**OBJECTION TO APPLICATION NO. SSD-10471  
WINTERBOURNE WIND TURBINE DEVELOPMENT**

SR007 REPLY TO:  
**RE-EXHIBITION**  
AMENDMENT TO EIS  
AND RESPONSE TO  
SUBMISSION

**RE:** 1878 WINTERBOURNE ROAD, WALCHA NSW 2354  
OBJECTION TO ALL OF THE PROPOSAL - SSD-10471

### Sight Lines to 5 Turbines – Perspective View

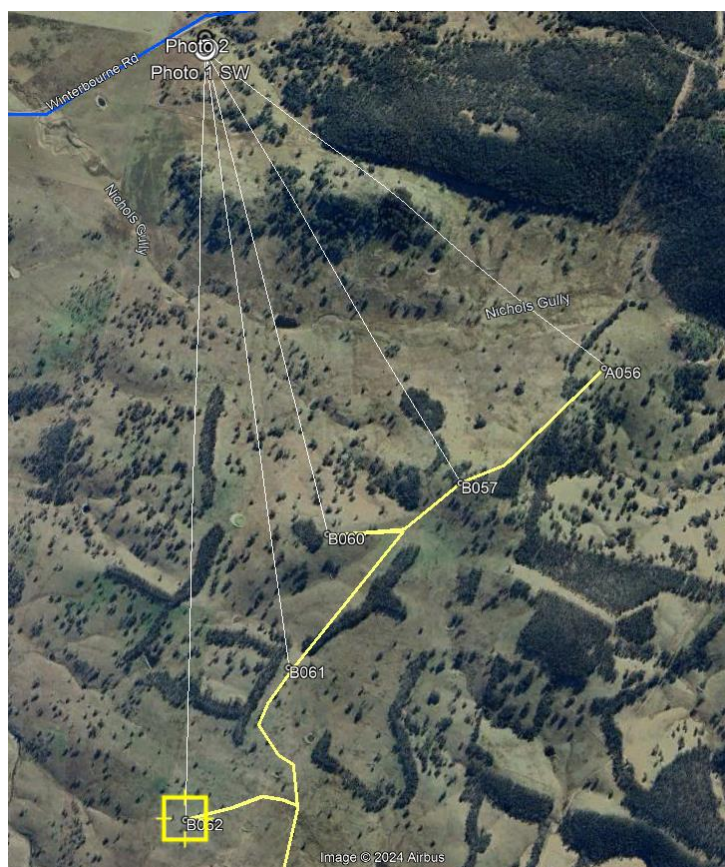
Sight lines to Turbines  
– as labelled. Vertical  
height of topography  
is at the same scale  
as vertical height of  
turbine. Horizontal  
scale is not matched  
to vertical scale, but  
this does NOT  
change the line of  
sight. Horizontal scale  
has been  
compressed for ease  
of viewing.

Independent Assessment of Closest 5 Turbines:  
B056, B057, B060, B061 & B062

Viewpoint – matching the site that the photo montages were taken from.

260m Turbine  
A056 to Scale

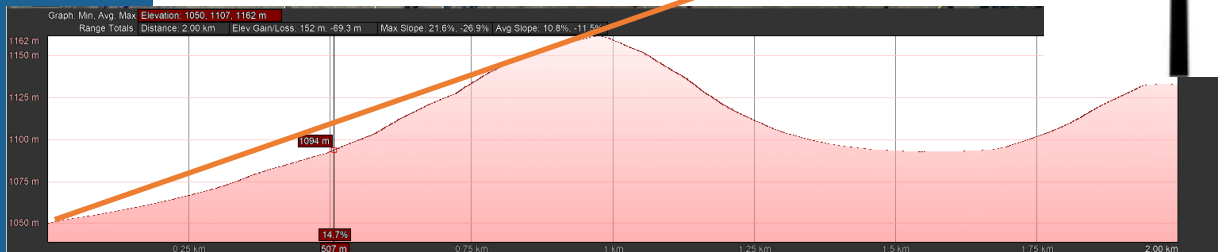
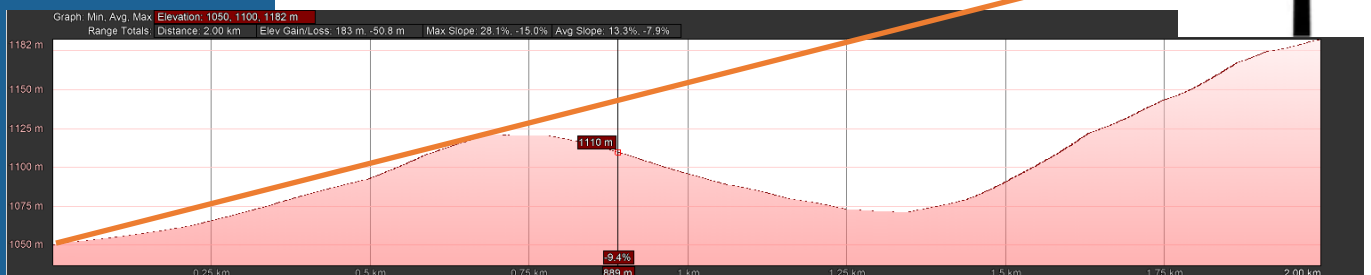
Developer montage  
shows just the very tip  
of the blade visible.

Developer montage  
shows smaller visible  
stand.

260m Turbine  
A060 to Scale

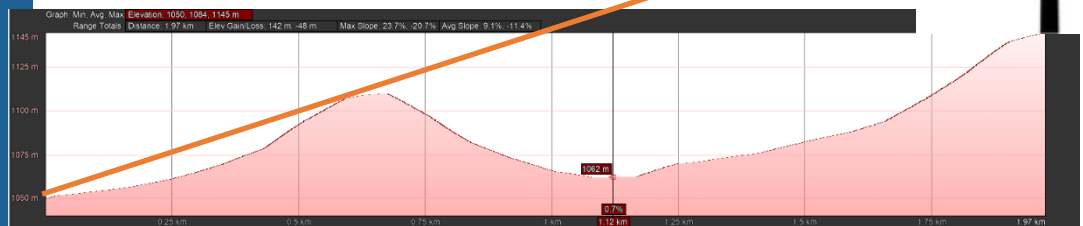
The Developer  
montage shows only  
the hub and small  
part of stand visible

The Developer  
montage shows only  
the very tip of the  
blade is visible

The Developer  
montage shows  
nothing but loads of  
red lines depicting  
where turbines are  
but can't be seen.
